Application for Licence Amendment

Applicant:	Alcoa of Australia Limited
ACN:	004 879 298
Licence Number:	L5271/1983/14
File Number:	DEC643
Premises:	Pinjarra Refinery Lot 19 on Diagram 44739, Part of Lot 109 on Diagram 60089, Part of Lot 151 on Plan 10914, Lot 221 on Plan 302632, Lot 222 on Plan 302638, Part of Lot 251 on Plan 35963 and Lot 252 on Plan 35963
Date of Report:	Friday, 28 July 2017
Status of Report:	Final

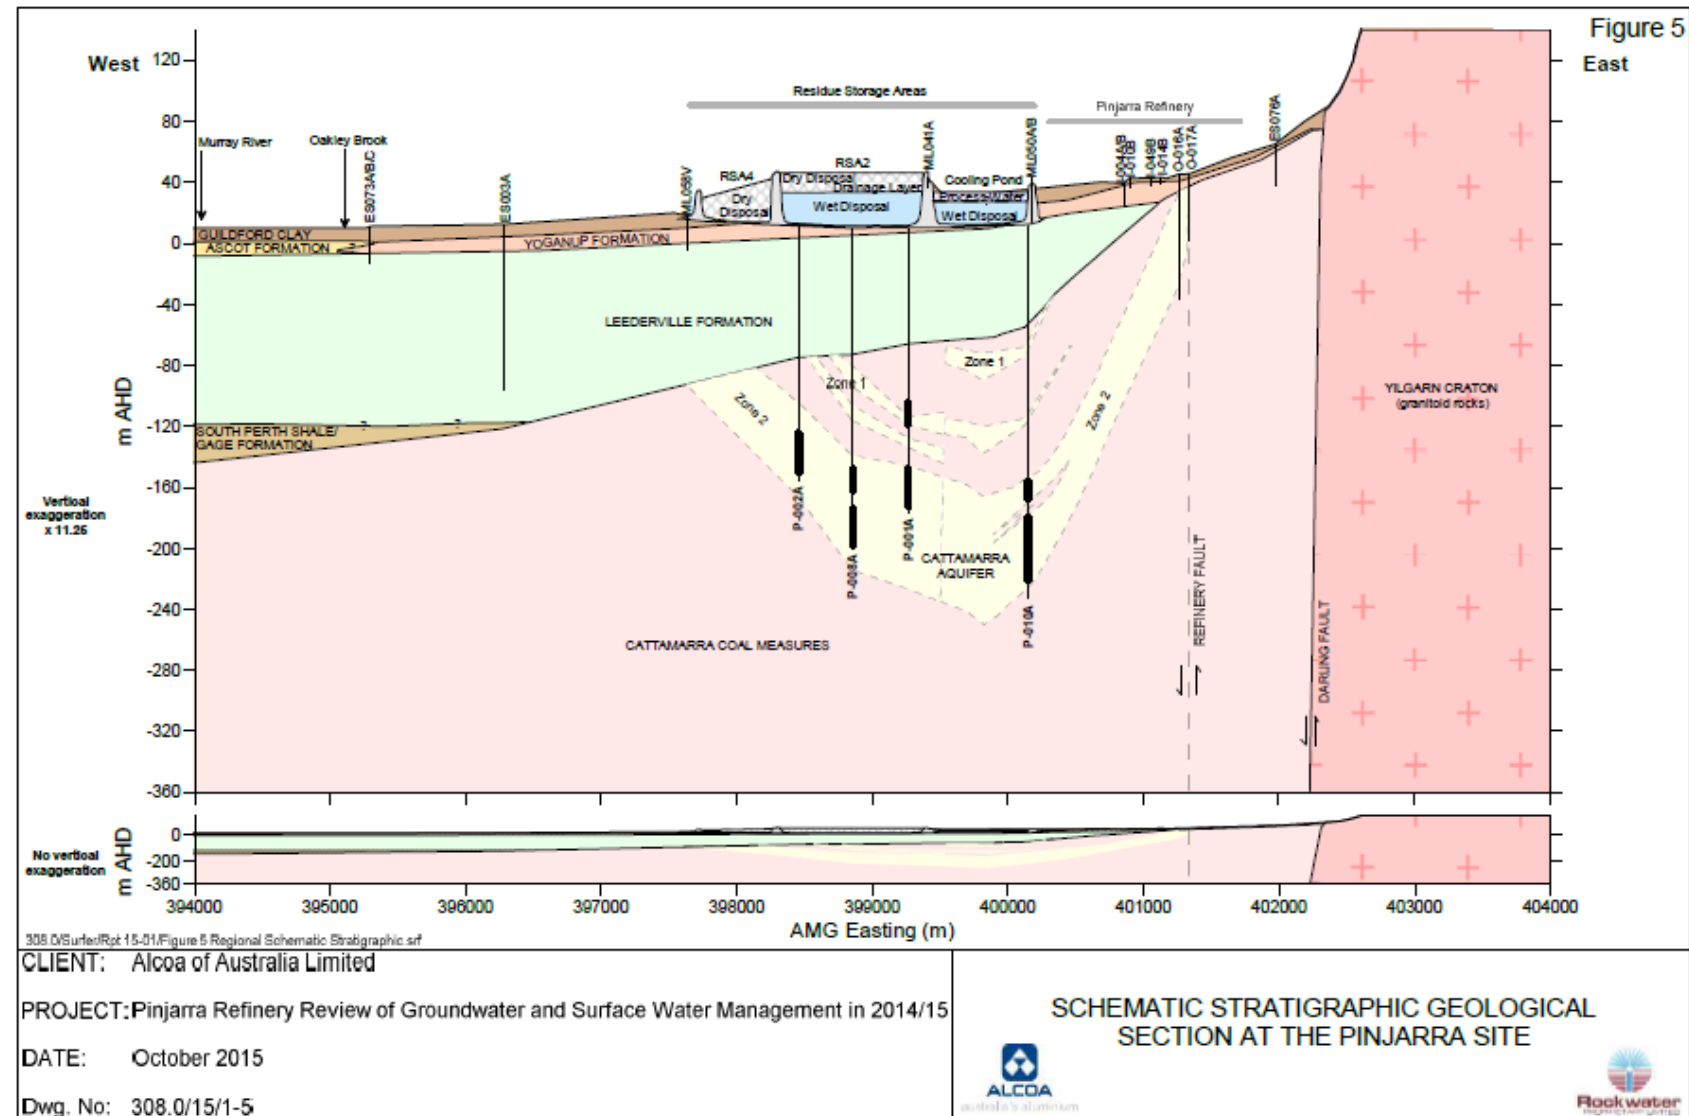
23	Location and Siting, Item 6, Pg.8	Alcoa notes that Figure 6 labelling is incorrect. What is designated in the figure as an artificial water body is the Water Corporation's Pinjarra waste water treatment plant.	<p>Figure 6 was sourced from the Licence Holder's 2012 LTRMS as referenced. The Delegated Officer is aware the artificial body is the licensed Pinjarra WWTP and did not consider the impact of surface or groundwater Risk Events on the WWTP lagoons in the assessment.</p> <p>Outcome: Text inserted to clarify that the depicted water body is the Pinjarra WWTP.</p>
